DEVIATION REVIEW AND DECISION FORM

Subdivision or Project Name: Springs East at Waterview, Preliminary Plan

Section of ECM from Which Deviation is Sought: 2.3.7.D.1

Specific Criteria from Which a Deviation is Sought: Turn Lane Design

Figure 3

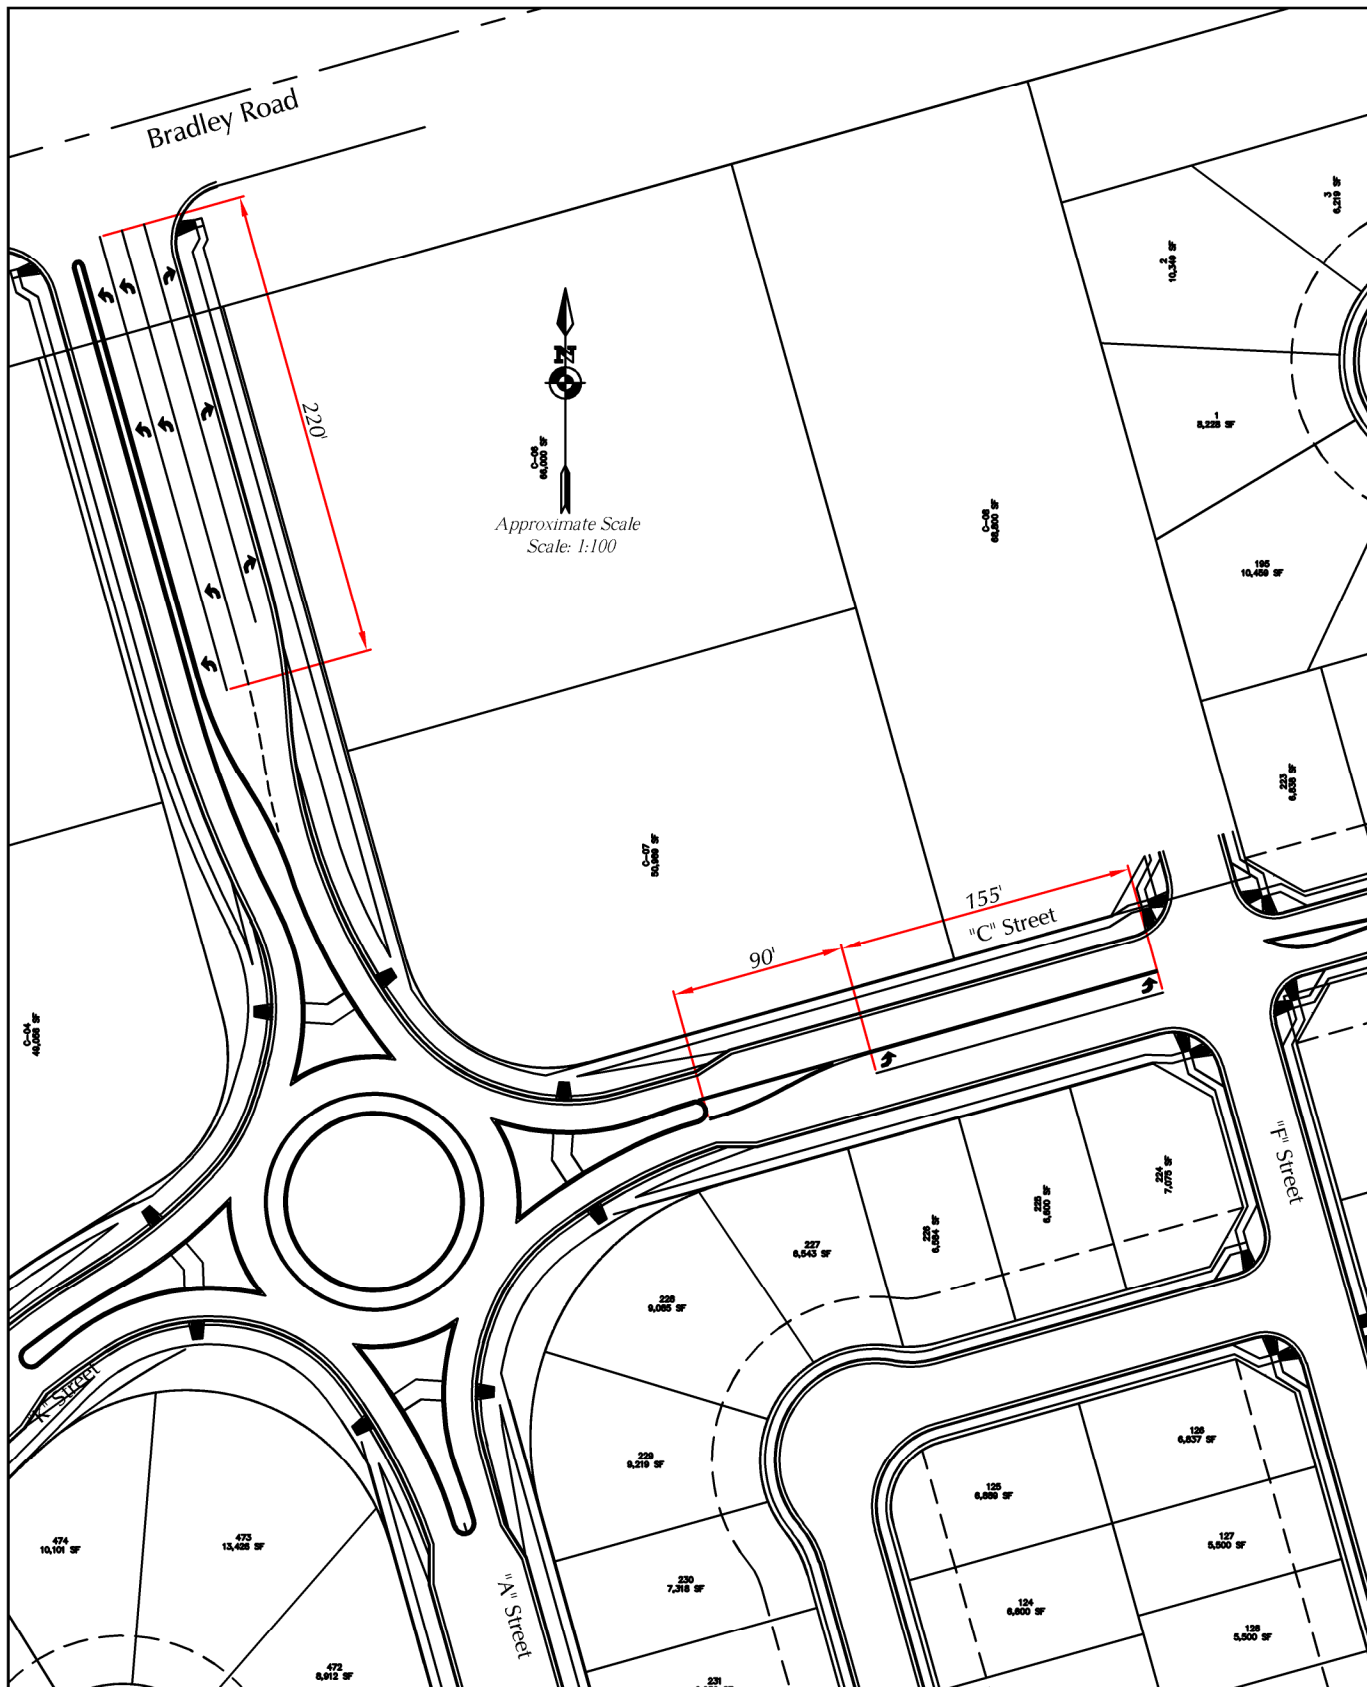
Comparison of Proposed Deviation to ECM Standard: The ECM standard for a 40-mph design speed limit is 155 feet of full-width lane plus a 160-foot taper plus storage distance. The turn lane geometry for the left-turn lane on C Street would be about 155 feet with about a 90-foot reverse curve taper. The projected maximum queue length from the TIS is 31 feet. In this situation, it would be reasonable to include the stacking distance within the 155-foot deceleration distance (which will be provided). The standard ECM taper is 160 feet. However, the ECM allows for a taper ratio of 8:1 for tangent bay tapers in constrained locations. Based on a lane width of 12 feet the 8:1 ratio would result in a prescribed 96-foot tangent bay taper. The proposed, estimated 90-foot-long taper would be 6 feet short of the ECM standard. The tapers would be designed with the roundabout, its splitter islands, and exit lanes.

The 2040 queueing analysis contained in the TIS indicates that the proposed eastbound left-turn lane length will be able to accommodate the projected queue. The turn lane geometry for the left-turn lane on C Street would be about 155 feet with about a 90-foot reverse curve taper as shown in the attached exhibit. The projected maximum queue length from the TIS is 31 feet. Given the site-specific conditions, including the stacking distance within the proposed standard 155-foot deceleration distance would work acceptably and would not adversely affect safety or operations. The taper would be designed with the roundabout, its splitter islands, and exit lane, however the preliminary concept indicates a bay taper length of about 90 feet. This length will be appropriate for the situation and will not adversely affect safety or operations.

This request has been determined to have met the criteria for approval. A deviation from Section 2.3.7.D1 of ECM is hereby granted based on the justification provided. Comments:
